Application No. A/K14/838

**Section 16 Application for Partial Conversion of an Existing Commercial Building for
Proposed 'Hotel (Student Hostel)' Use at 86 Hung To Road, Kwun Tong, Kowloon**

Submission of Further Information 2

Further Information 2

Figure 2.3: Air Intake Location and Sensitive Use within the Project Building

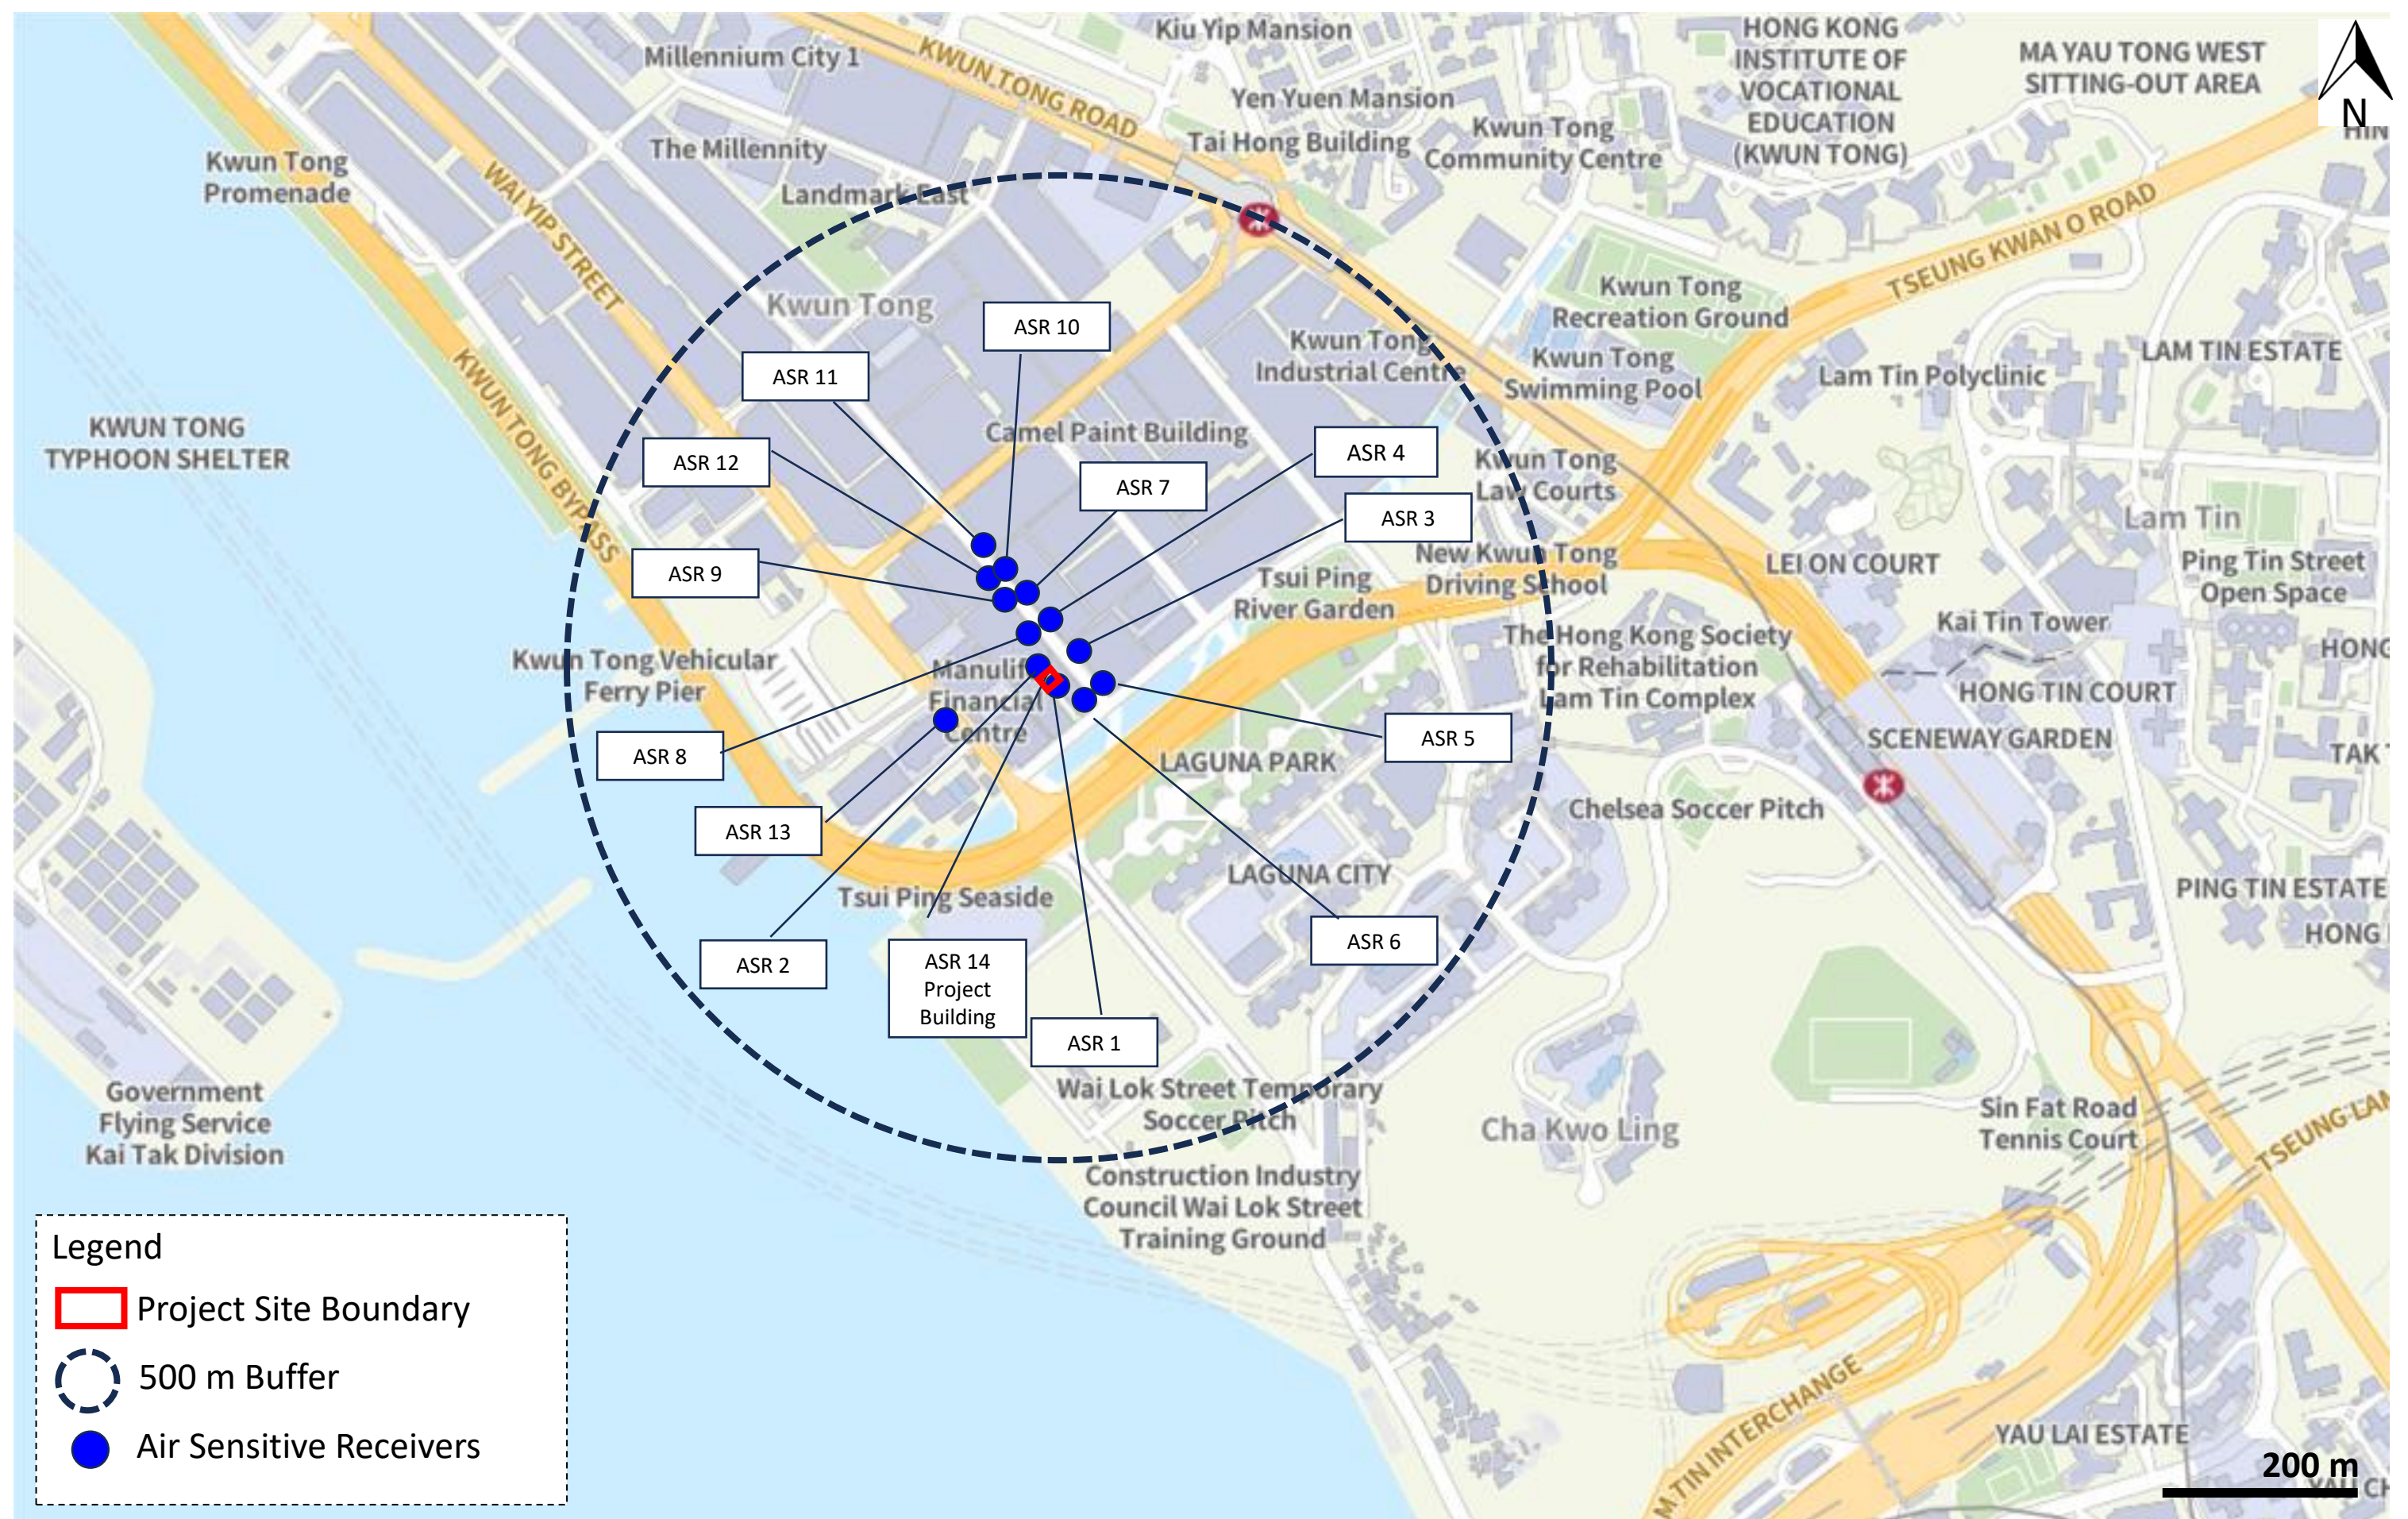
9.	Section 2.4.4, Table 2.5, Figure 2.3 & R-t-C#8: (a) In Table 2.5, please amend the distance between the project building and Hung To Road, which should not be 7m as per Section 2.4.4. (b) Figure 2.3: Please mark the 5m buffer distance from Hung To Road to demonstrate compliance with the 5m buffer distance requirement. Please also compare the 5m buffer distance of Hung To Road against the layouts of all floors to determine which windows should be sealed. Please quote Figure 2.3 in Section 2.4.4.	Noted. Table 2.5 has been updated accordingly. Noted. The 5m buffer zone and sealed windows positions have been marked on Figure 2.3 .
